From: Wooldridge, John
Sent: Monday, May 11, 2020 5:12 PM
To: Walker, Luke; Morgan, Douglas; Heim, Kimber
Subject: RE: FAI-37-6.34 Preliminary Right of Way Plans (PID No. 110412)
Attachments: Email 043020 Village of Thurston Utility and RW Contact Info.pdf

Subject: FAI-37-6.34 Preliminary Right of Way Plans (PID No. 110412)

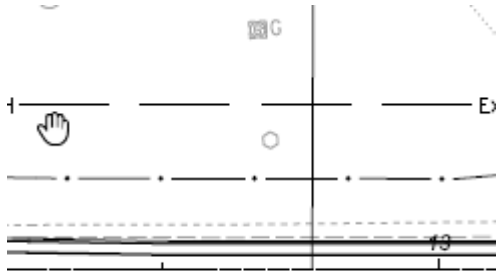
- Missing sheet 20 of 37 as Luke stated.
- Page 21/36 (22/37) Parcel 11-SH shows "Utility Pole Save" for private light poles. I would have them removed as ODOT will need to pay for them anyways (in take area) and would need to do a permit (not recommended) for the poles that are very close to the fence needing removed. Same Parcel has three of those poles (not 2) and also has a small sign near the fence that was not picked up on these plans:
